ADDENDUM No. 1

Hoover, Greene, & Hill Improvement Project

ADDENDUM No. 2

Hoover, Greene, & Hill Improvement Project

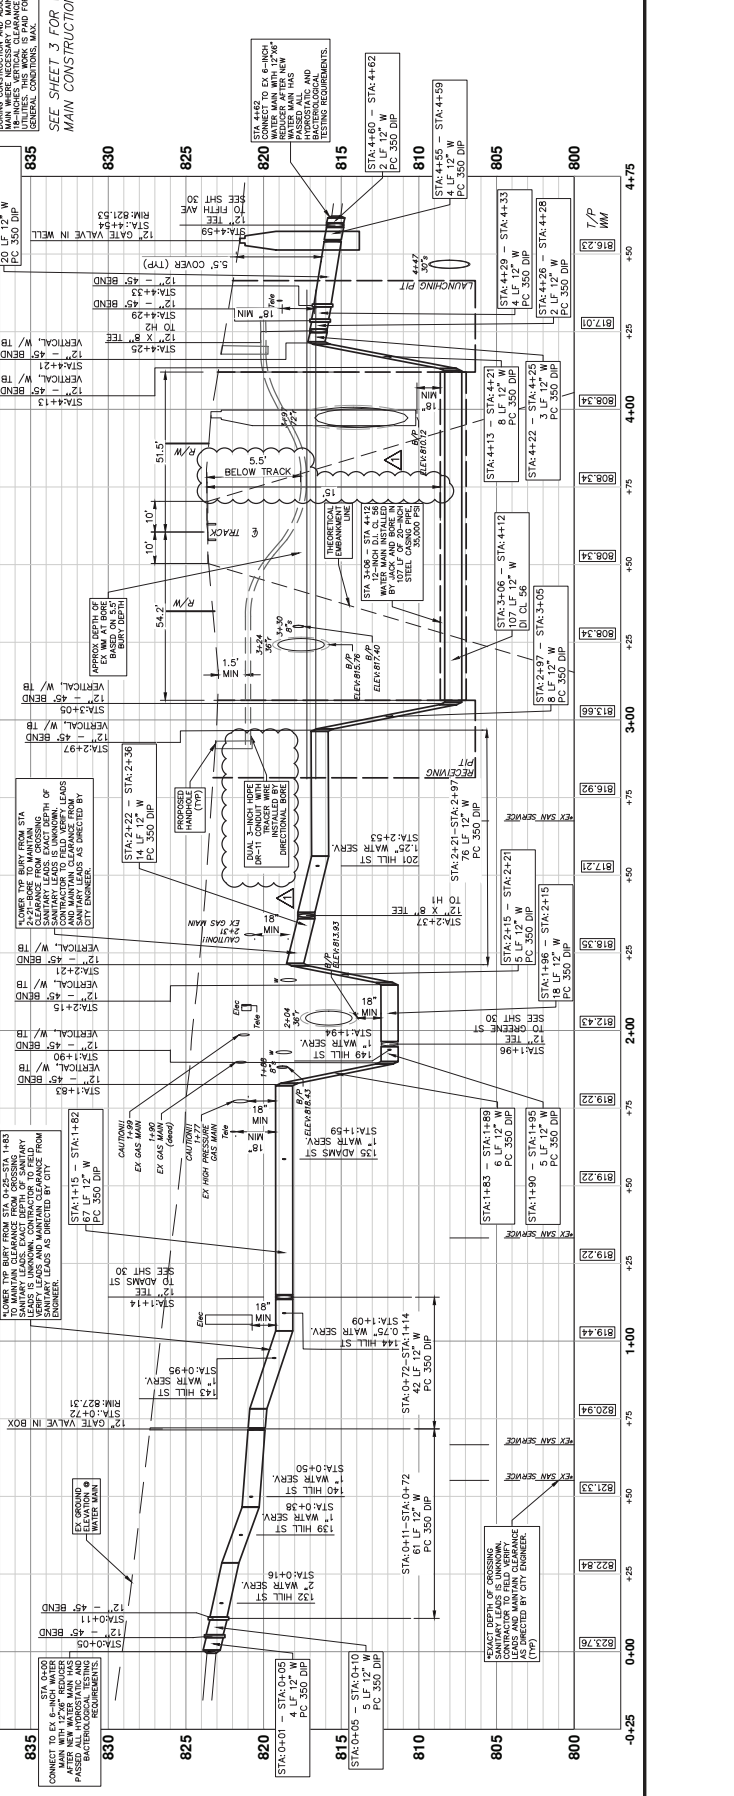
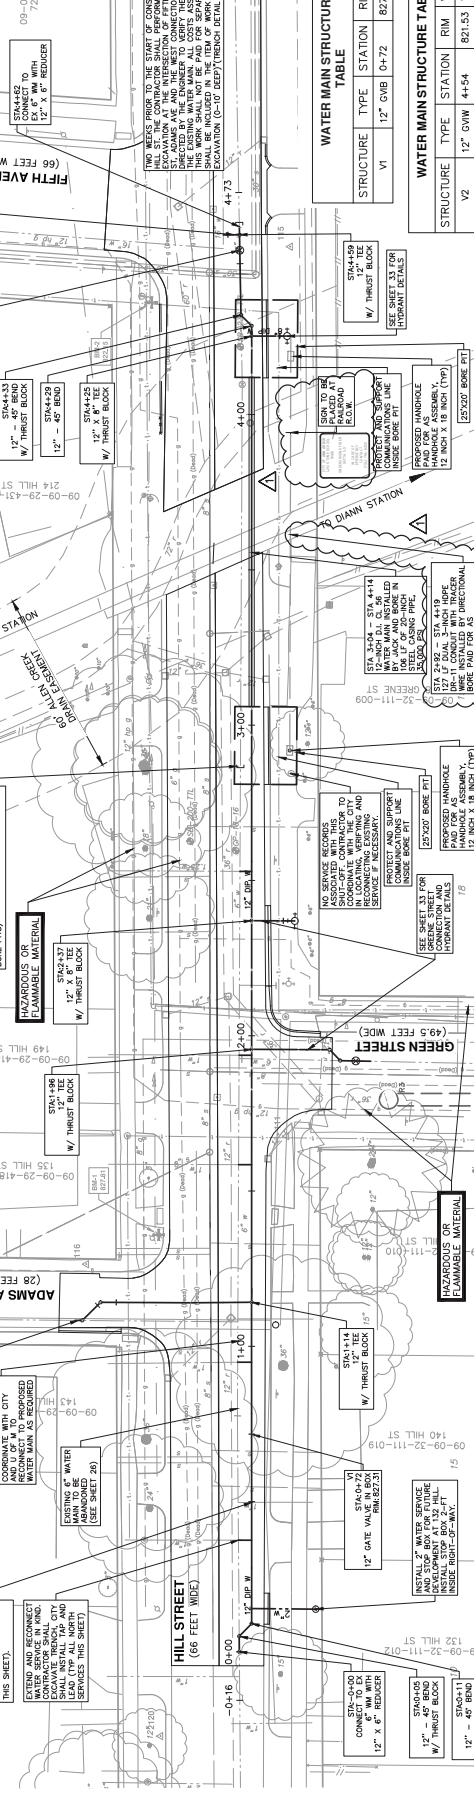
Plan Sheet 32 of 83 Remove plan sheet 32, "Water Main Plan and Profile – Hill Street", and replace with plan sheet 32 dated 02/22/19 and designated Addendum No. 2 (copy attached). Changes as noted on sheet. Dimension added in profile view below track to top of conduit and jack and bore casing pipe. Dual 3-inch conduits shall be bored under tracks. Additional signs required at railroad ROW (to be installed by City).

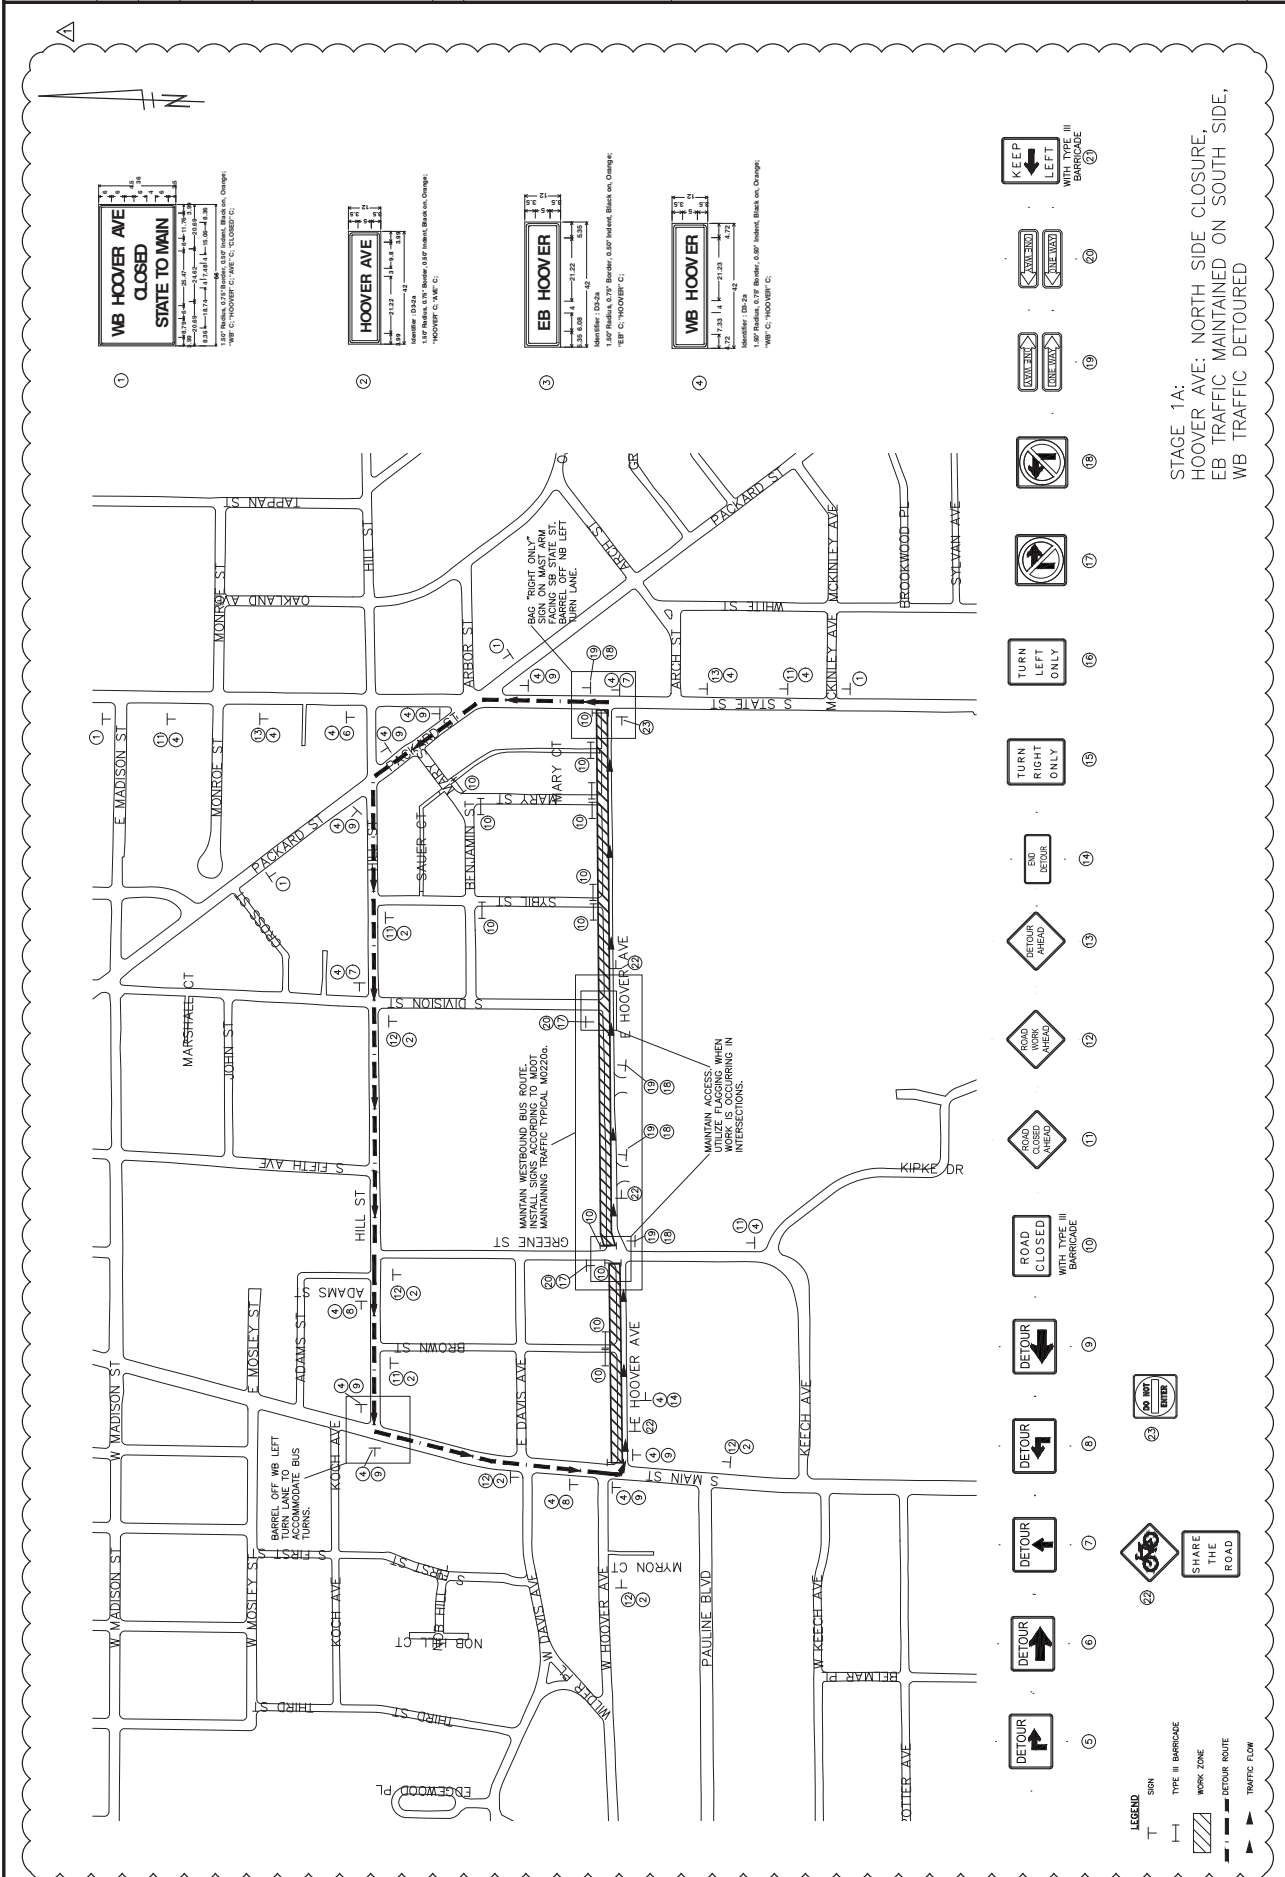
Plan Sheet 71 of 83 Remove sheet 71 and replace with "Hoover MOT – Westbound Lane" plan sheet 71 dated 02/22/19 and designated Addendum No. 2 (copy attached). Changes as noted on sheet.

Comment: The plan sheet has been revised for the extended construction timeframe and staging changes.

STAGE 1B:
HOOPER AVE: SOUTH SIDE CLOSURE,
EB TRAFFIC MAINTAINED ON NORTH SIDE,
WB TRAFFIC DETOURED

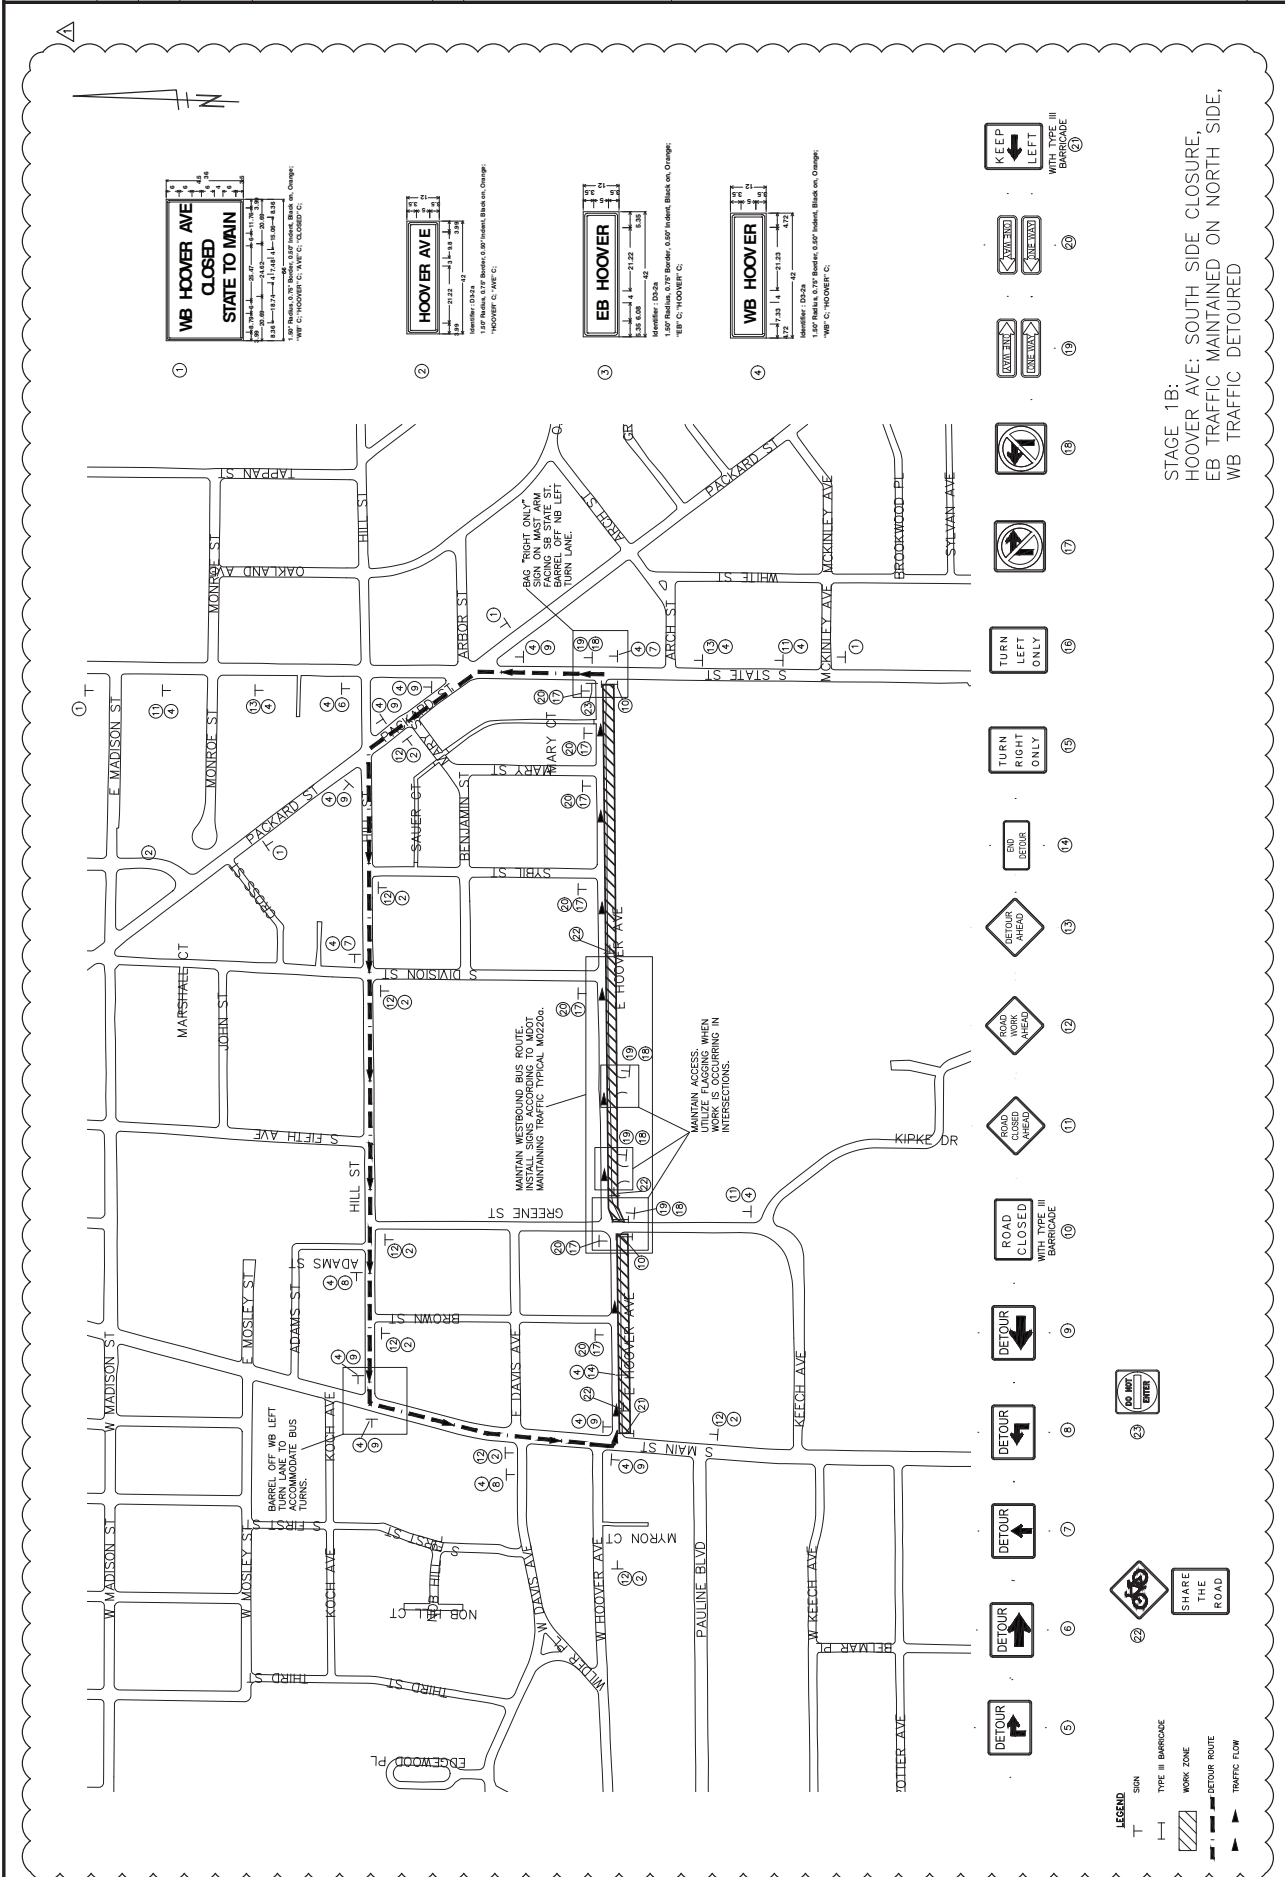
Plan Sheet 72 of 83 Remove sheet 72 and replace with "Hoover MOT – Eastbound Lane" plan sheet 72 dated 02/22/19 and designated Addendum No. 2 (copy attached). Changes as noted on sheet.

Comment: The plan sheet has been revised for the extended construction timeframe and staging changes.

STAGE 1C: HOOPER ST CLOSURE AT RAILROAD

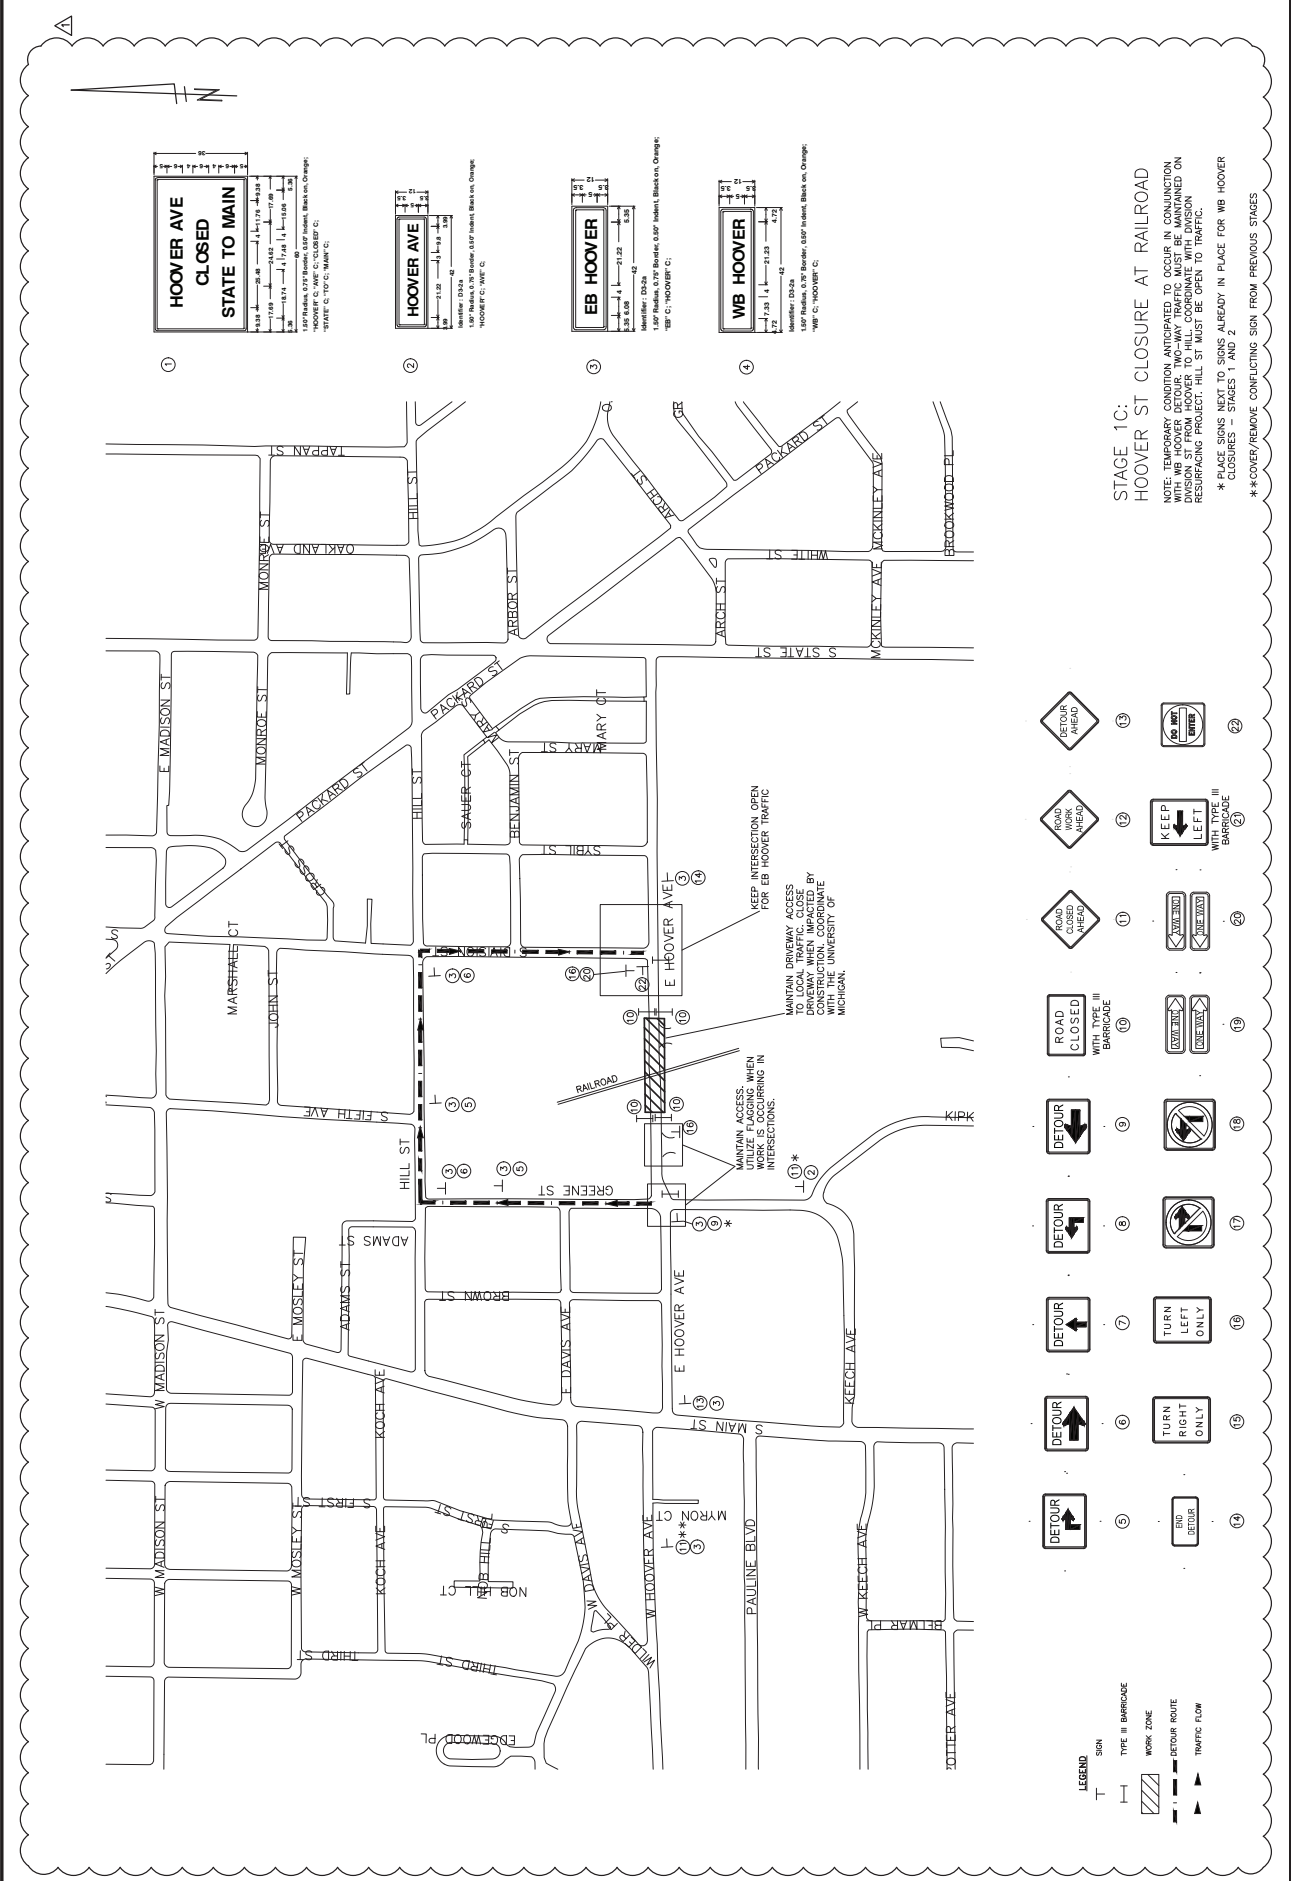
Plan Sheet 73 of 83 Remove sheet 73 and replace with "Hoover MOT – Railway Closure" plan sheet 73 dated 02/22/19 and designated Addendum No. 2 (copy attached). Changes as noted on sheet.

Comment: The plan sheet has been revised for the extended construction timeframe and staging changes.
